ADDENDUM #2
ALLEN AVENUE SANITARY SEWER REPLACEMENT GP-1332 PART 1
14TH STREET WATERLINE REPLACEMENT PART 2
CITY OF CANTON

Friday, February 11, 2022

This Addendum is being issued to provide additional clarification on the plan sheets, additional information related to the project including plan notes and details, and to respond to questions submitted by Bidder's during the written question's submittal period.

CONSTRUCTION
DETAILS

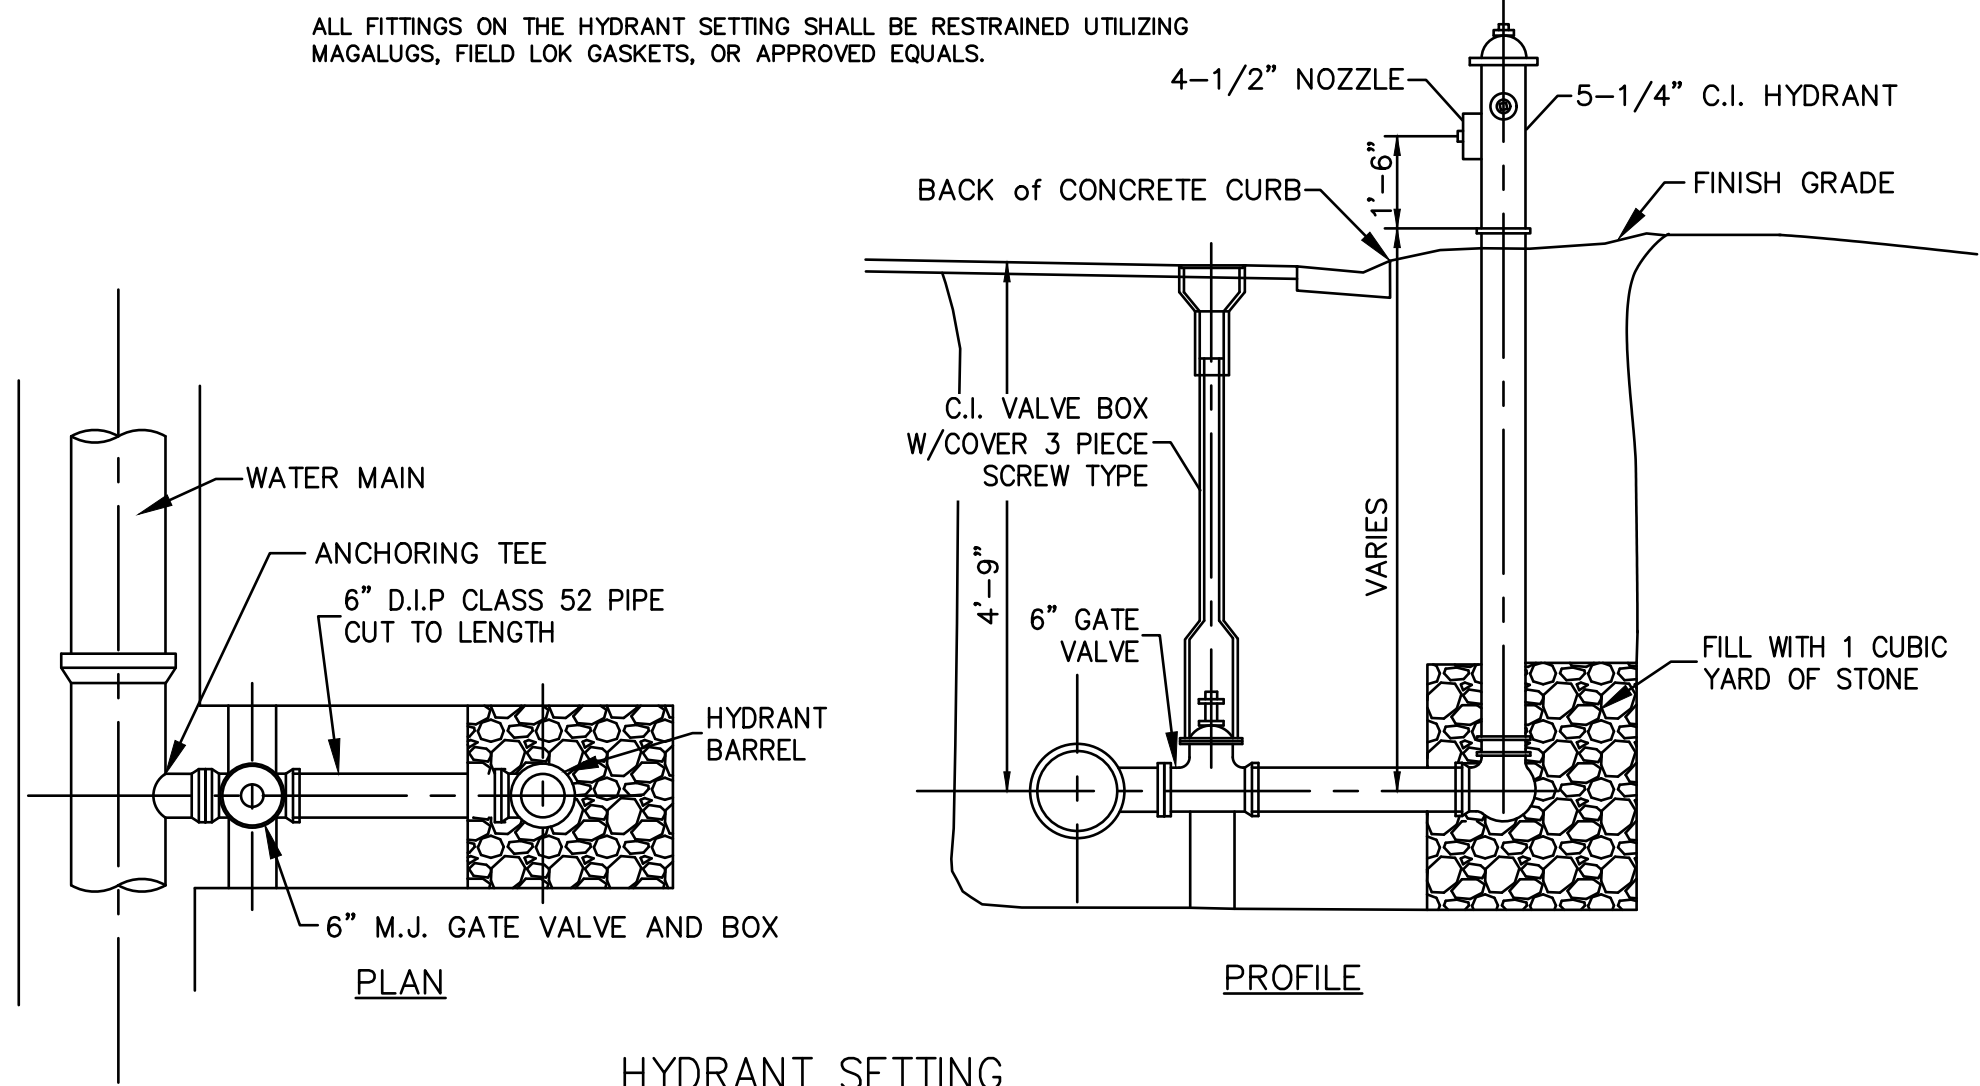
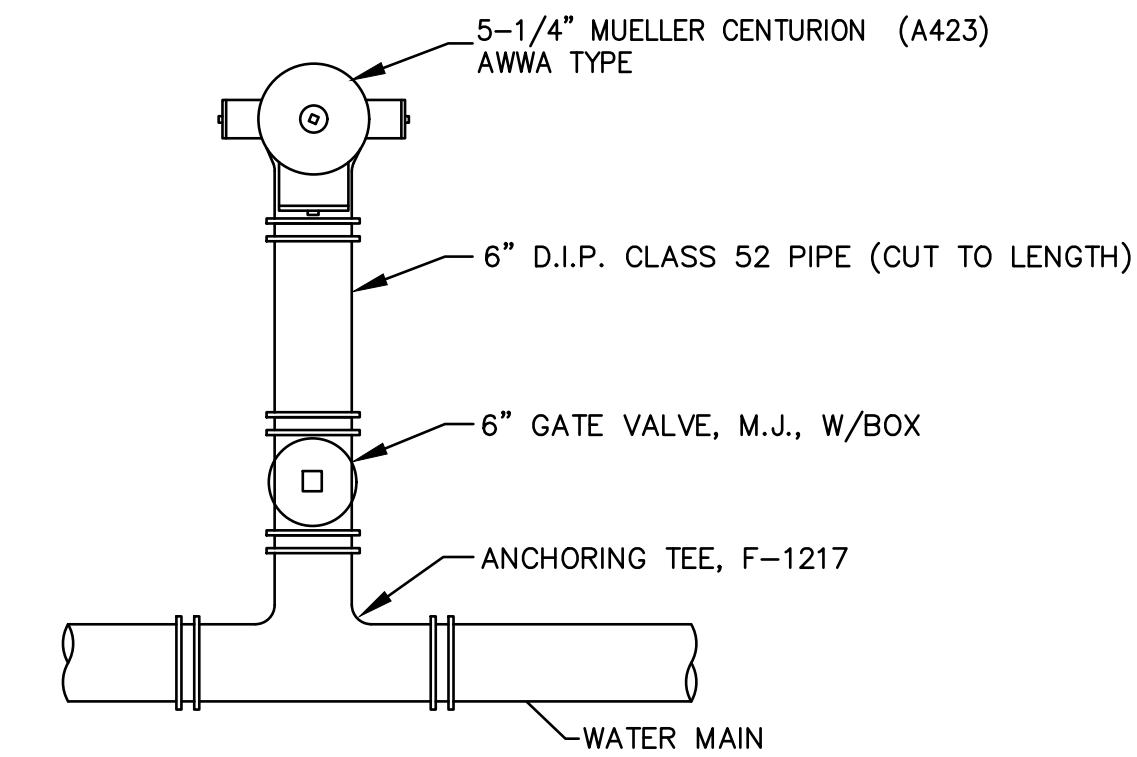
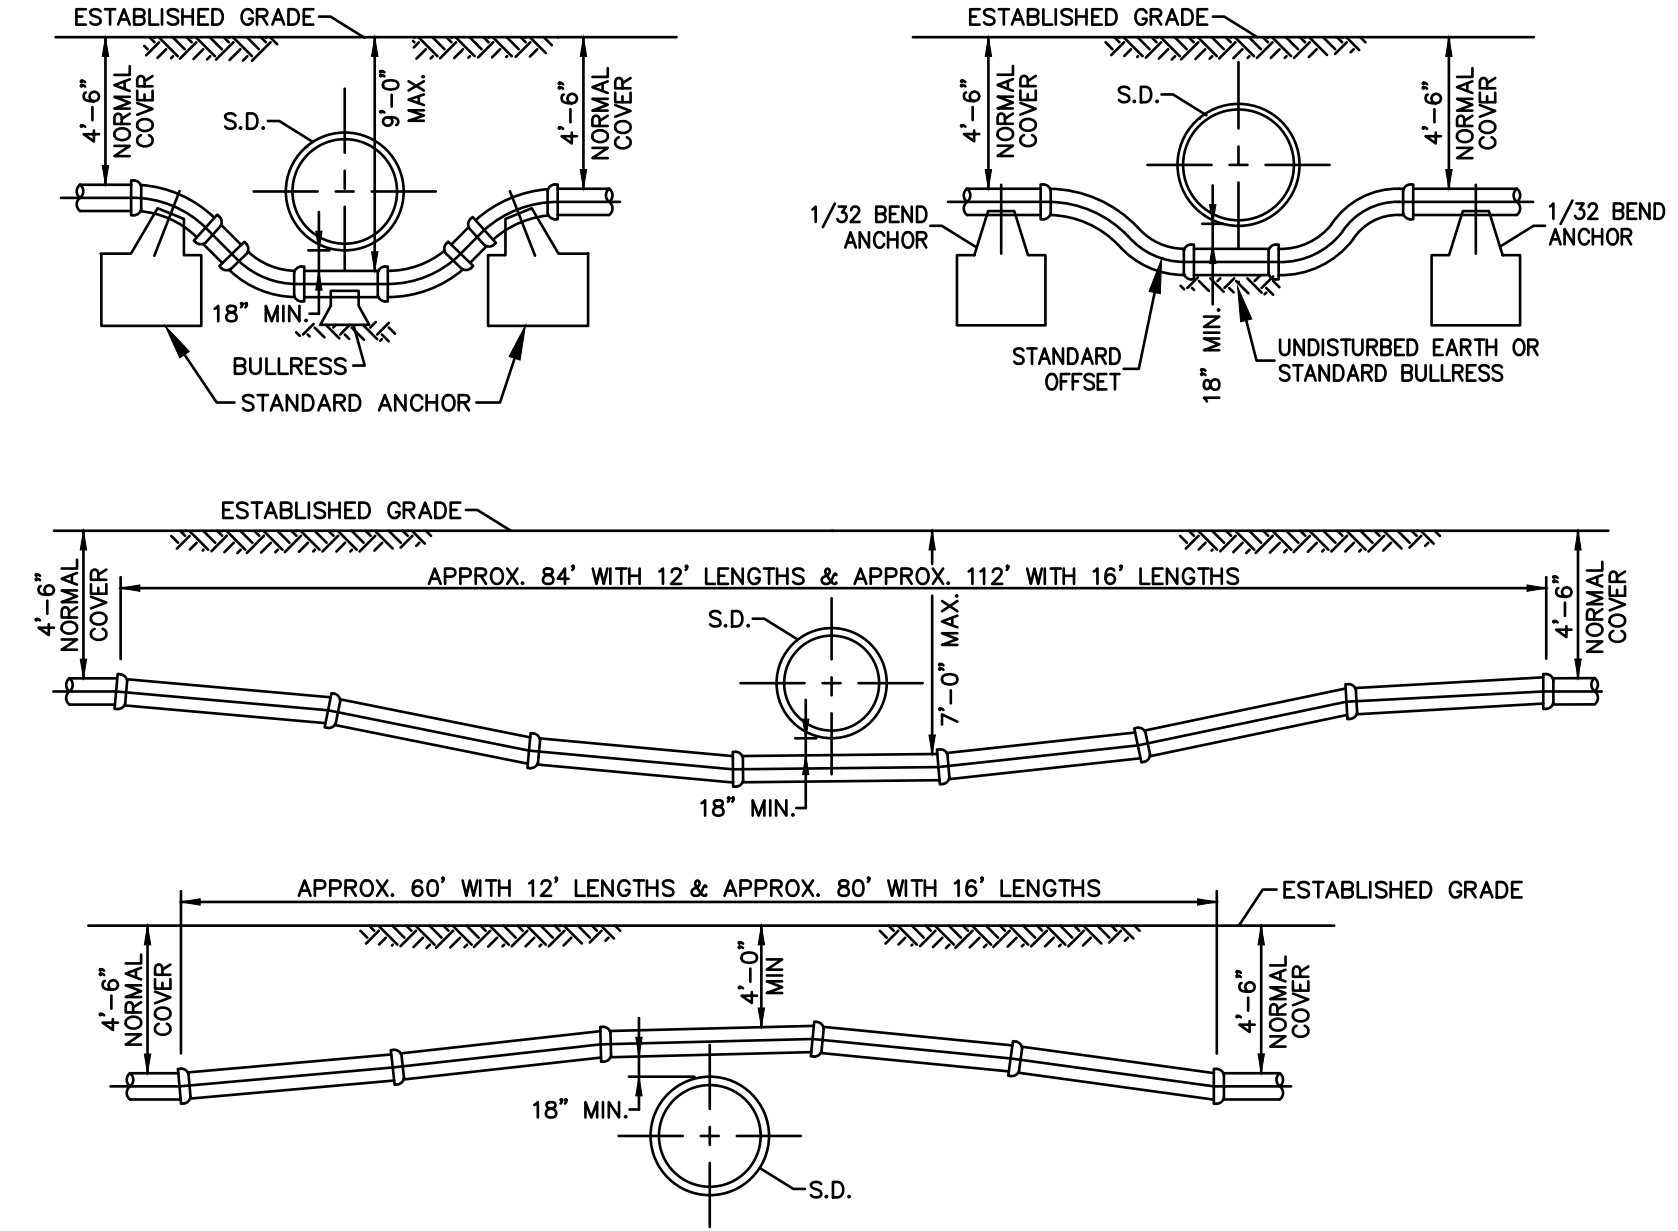
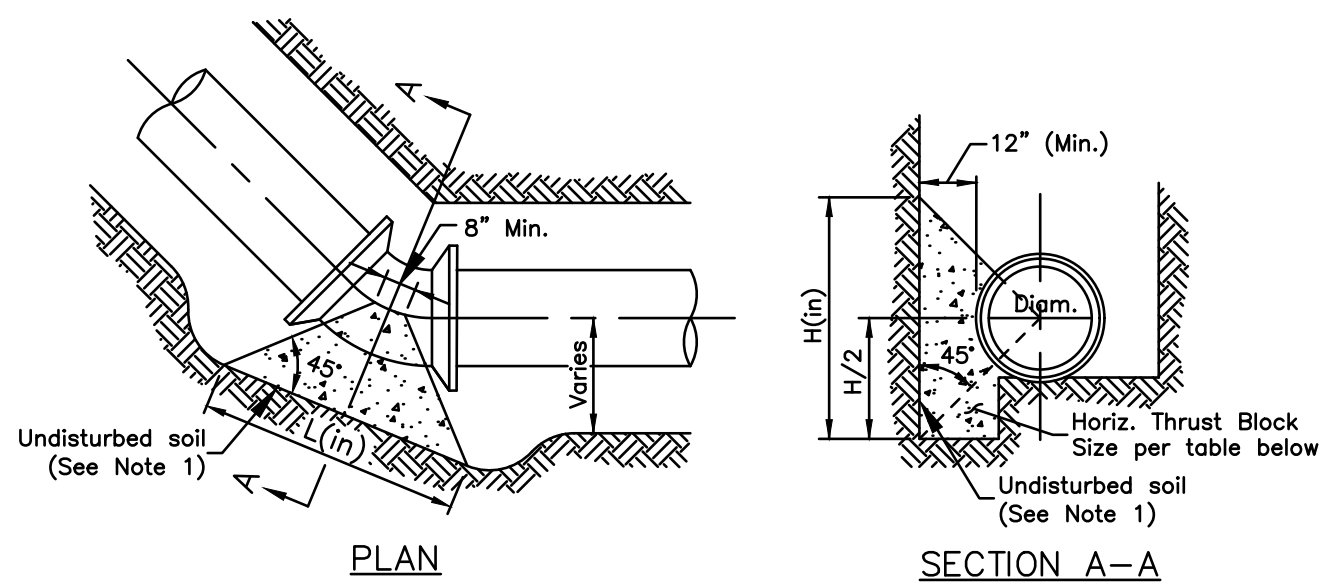
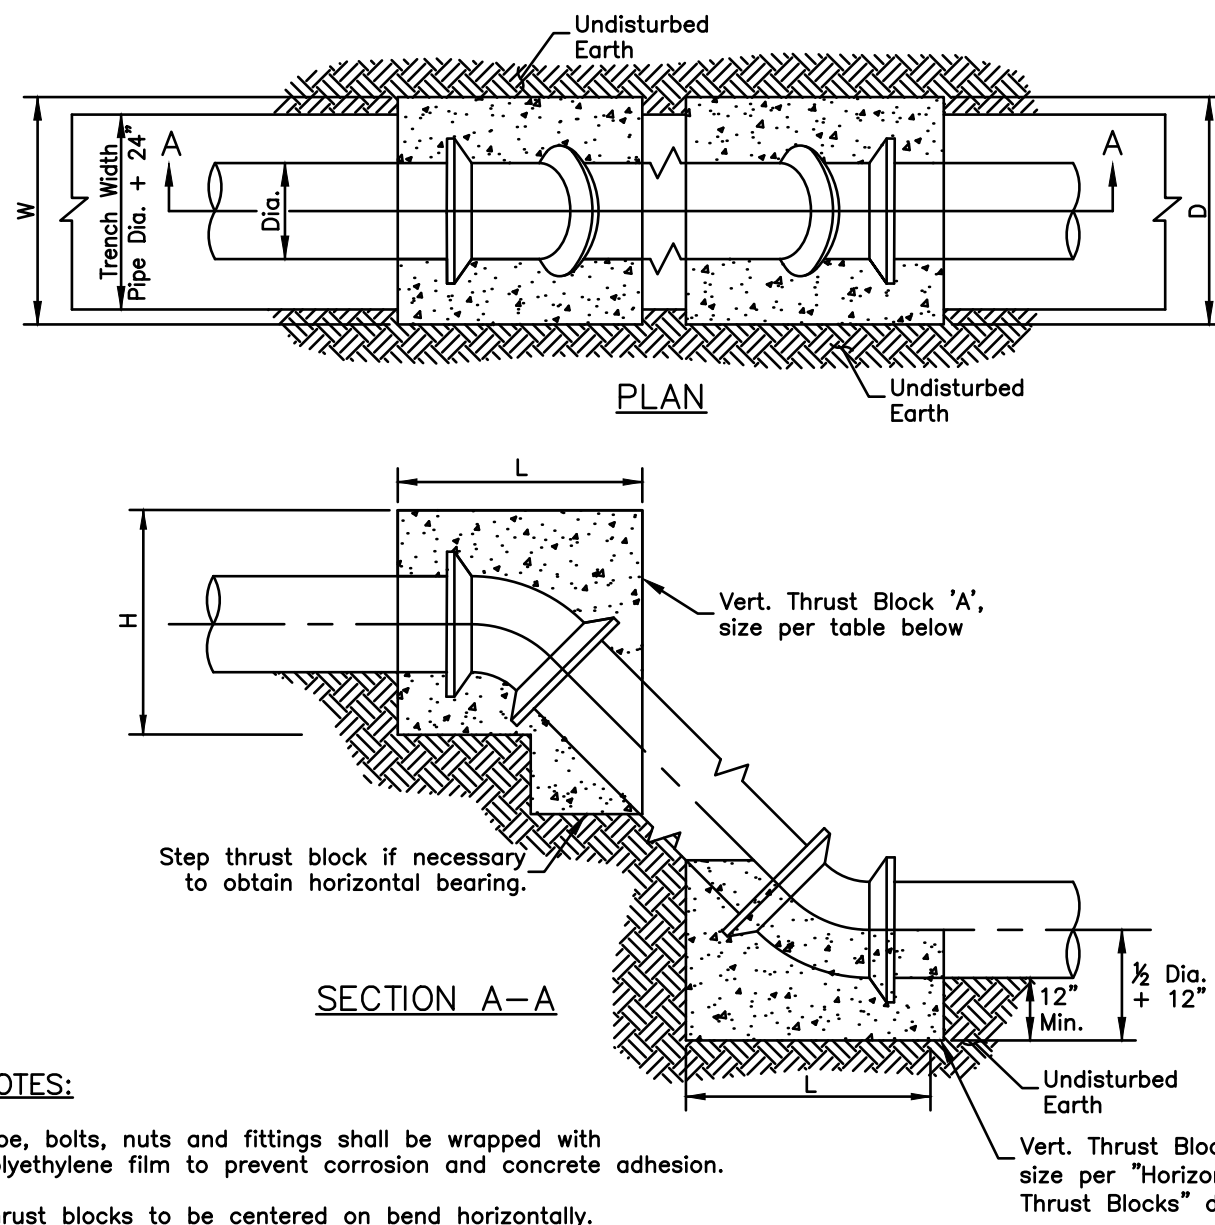
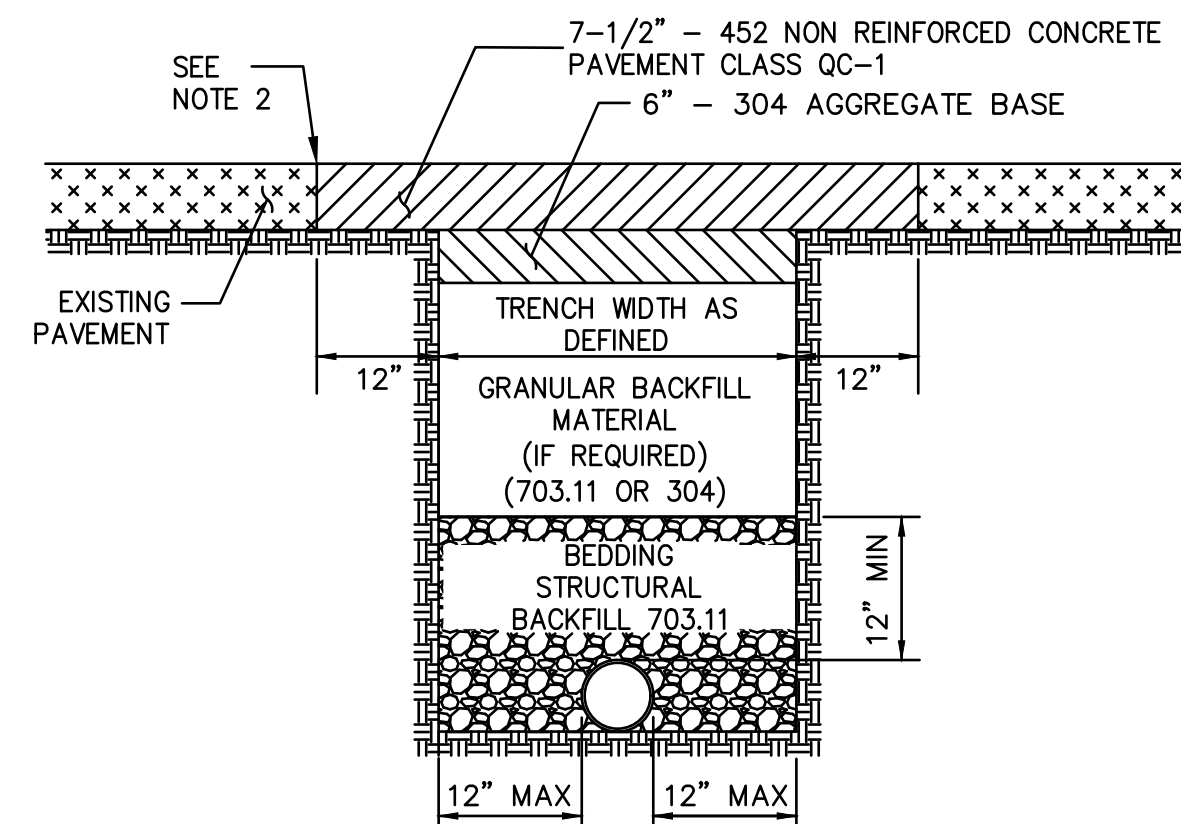
- N. What is the requirement on bedding for water mains? Detail shows 703.11 but doesn't specify what type. All types of 703.11 are acceptable.
- O. There is no detail showing the composition of the existing pavement at each location, nor is there a pavement restoration detail provided for each street and alley. Can this be provided for bidders? Pavement shall be repaired per Office of the City Engineer Standard Drawings 31 & 32 and the Mill & Overlay Detail.

1. NO FOUNDRY SAND OR SLAG IS PERMITTED. ALTERNATE BACKFILL MATERIAL PERMITTED ONLY IF APPROVED BY CITY ENGINEER.
2. SAW CUT EXISTING PAVEMENT, SEAL JOINT PER ODOT ITEM 423 - CRACK SEALING, TYPE IV. INCLUDE COST IN BID PRICE FOR THE PROPOSED PAVEMENT.
3. IF ADJACENT PAVEMENT IS DAMAGED OR UNDERMINED DURING CONSTRUCTION, ADDITIONAL PAVEMENT SHALL BE SAW CUT AND REMOVED OR MILLED IN ORDER TO PROVIDE A SOUND PAVEMENT EDGE AT NO ADDITIONAL COST TO THE PROJECT.
4. IN THE EVENT THAT THE SAW CUT WOULD LIE WITHIN 3 FEET OF THE EDGE OF PAVEMENT OR FACE OF CURB, THE PAVEMENT REPLACEMENT SHALL EXTEND TO THE EDGE OF PAVEMENT OR FACE OF CURB.
5. ALL TYPES (1, 2, & 3) OF 703.11 BEDDING STRUCTURAL BACKFILL WILL BE ACCEPTED.
